**Planning Act 2008 (as amended)
Application by Roxhill (Junction 15) Limited for an Order granting Development
Consent for the Northampton Gateway Strategic Rail Freight Interchange
Examination – Updated Cumulative Impact Assessment**

UPDATED CUMULATIVE IMPACT ASSESSMENT WITH RAIL CENTRAL

**Updated Cumulative Impact Assessment with proposed Rail
Central scheme as accepted by Examination**

Figure 1: extract of Rail Central 2031 DS6 – DM AM peak flow difference plot

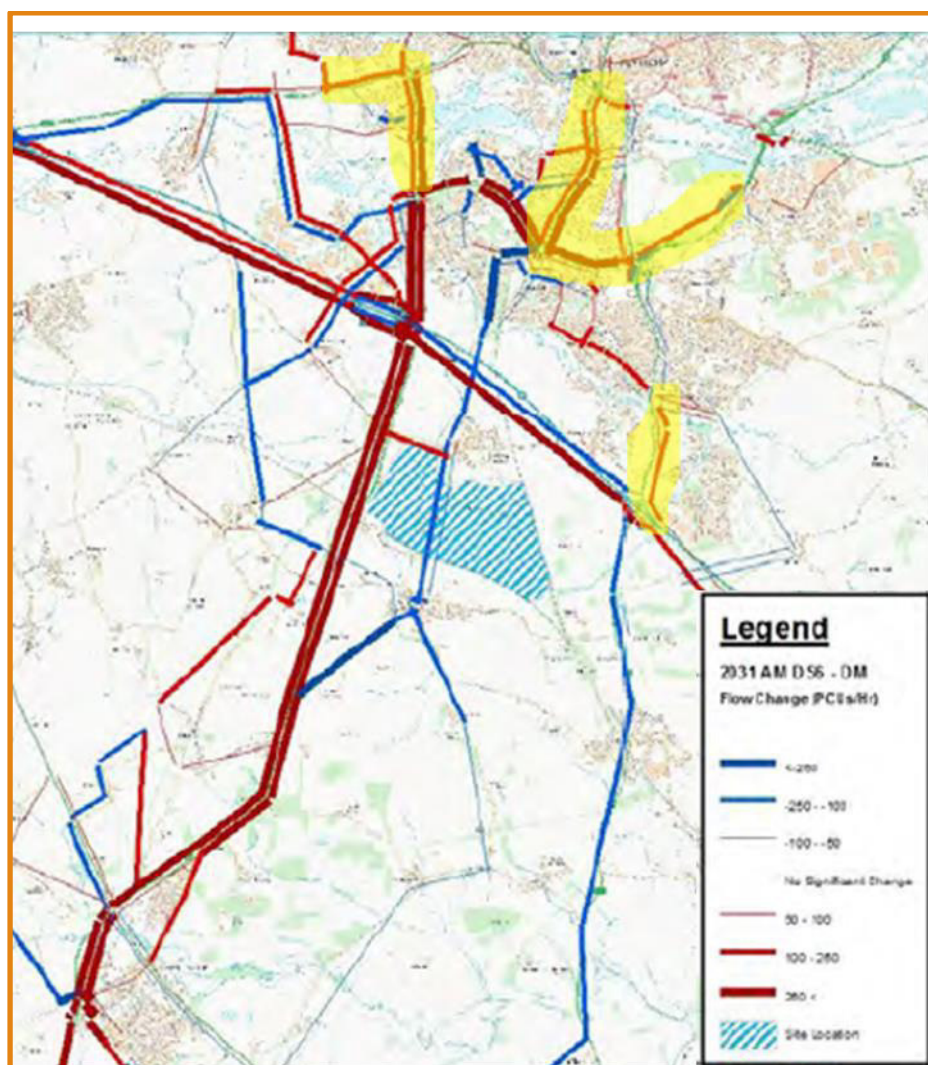
- 3.10 **Figure 1** shows that in the morning peak hour, traffic increases on the A43 and A5076 Ring Road corridors. This is as intended as part of the revised Rail Central highway mitigation strategy, which is to draw traffic onto these routes. However, as shown highlighted in yellow on **Figure 1**, from the A5076/Towcester Road/Tesco Roundabout, there would be significant traffic increases on Towcester Road north (to/from Northampton Town Centre)

- 3.11 As highlighted in yellow on **Figure 1**, there would be significant traffic increases north of the A5076/A5123/Upton Way Roundabout on the A5076 Upton Way. The Stage 2 Statutory Consultation draft TA proposed mitigation at the A4500 Weedon Road/A5076 Upton Way/Tollgate Way gyratory. However, impacts at this junction are not now considered in the Rail Central TA, and the improvement scheme is no longer part of the Rail Central highway mitigation strategy.

- 3.12 **Figure 1** also shows that there continues to be traffic increases on the A45 between the Queen Eleanor Interchange and the Barnes Meadow Interchange, and also to the south of the Wootton Interchange (highlighted yellow).

- 4.33 **Figures 1 and 2** in Section 2 of this Technical Note show that in the 2031 DS6 scenario for Rail Central alone, there would be significant traffic increases from the Towcester Road/A5076/A5123/Tesco roundabout on Towcester Road North (to/from Northampton Town Centre) and on the A5076 Mere Way (to/from the A45 Queen Eleanor Interchange).

- 4.34 **Figures 1 and 2** also show significant traffic increases north of the A5076/A5123/Upton Way Roundabout on the A5076 Upton Way towards the A4500 Weedon Road/A5076 Upton Way/Tollgate Way gyratory.

- 4.44 **Figures 1 and 2** at Section 2 of this Technical Note show that the Rail Central mitigation strategy significantly increases flows on the A43 corridor, with some traffic increases on local roads to the west of the A43.

Figure 2: extract of Rail Central 2031 DS6 – DM PM peak flow difference plot

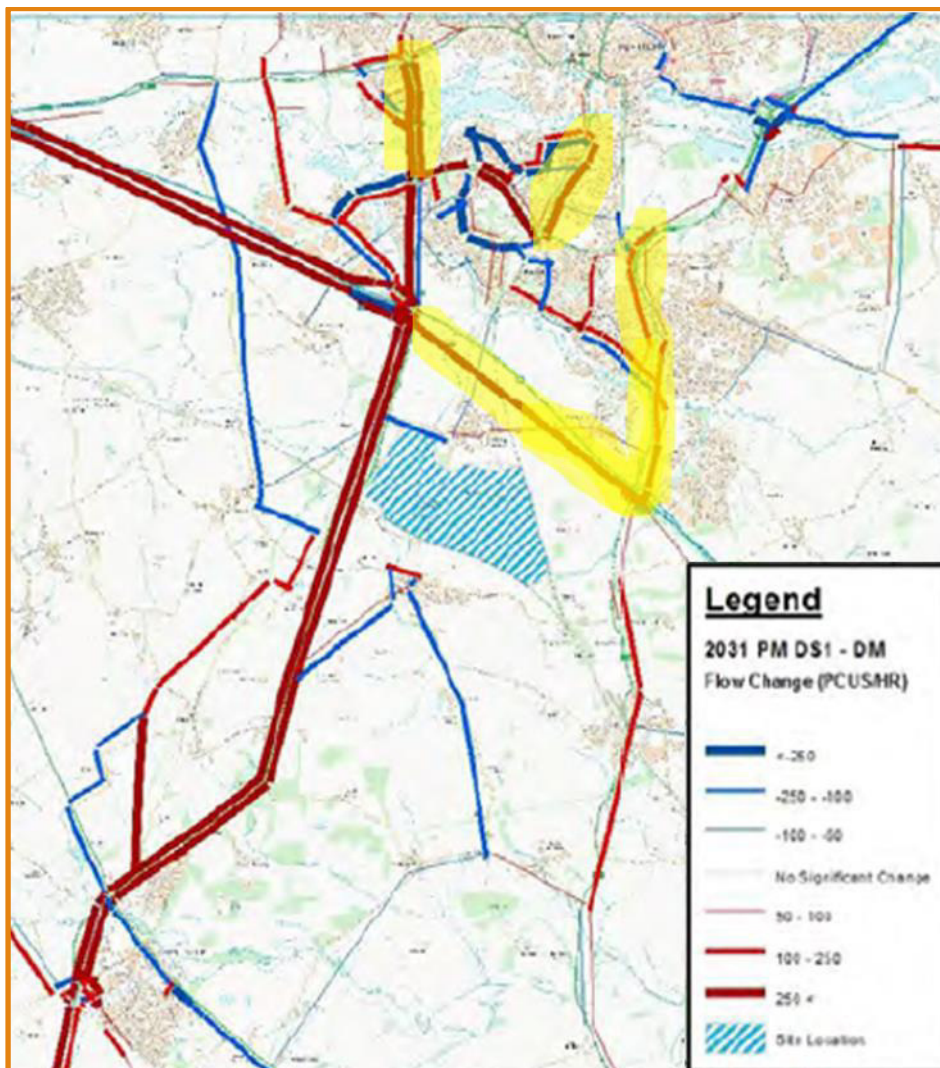
- 3.13 **Figure 2** below shows that in the evening peak hour, there would be traffic increases on the A43 and A5076 Ring Road corridors as intended as part of the revised Rail Central highway mitigation strategy to draw traffic onto these routes.

- 3.14 However, **Figure 2** also shows that southbound on the A5123 towards M1J15A there is a reduction in traffic. Further, there would be material traffic increases on the A45 between M1J15 and the Queen Eleanor Interchange and on the M1 towards M1J15A from the A45

(as highlighted yellow on **Figure 2**). This would suggest that the Rail Central strategy is not delivering as intended in the evening peak hour, as traffic is using an alternative route to reach M1J15A from the north.

- 3.15 In the evening peak hour, **Figure 2** shows that there are further traffic increases to the north of the A5076/Towcester Road/Tesco Roundabout along Towcester Road and north of the A5076/A5123/Upton Way Roundabout along the A5076 Upton Way. Further, **Figure 2** shows that traffic flows would also increase during the evening peak hour along the A508 through Road.
- 3.16 The change in traffic flows between the 2031 'do minimum' and 2031 DS1 (with Rail Central, no mitigation) scenarios are shown at Figures 30 and 31 in Systra's Strategic Modelling Assessment report (Appendix R of the Rail Central TA)). These figures show that without mitigation, the addition of Rail Central development traffic would significantly increase rat-running through the villages to the east and west of the A43 in both peak hours.
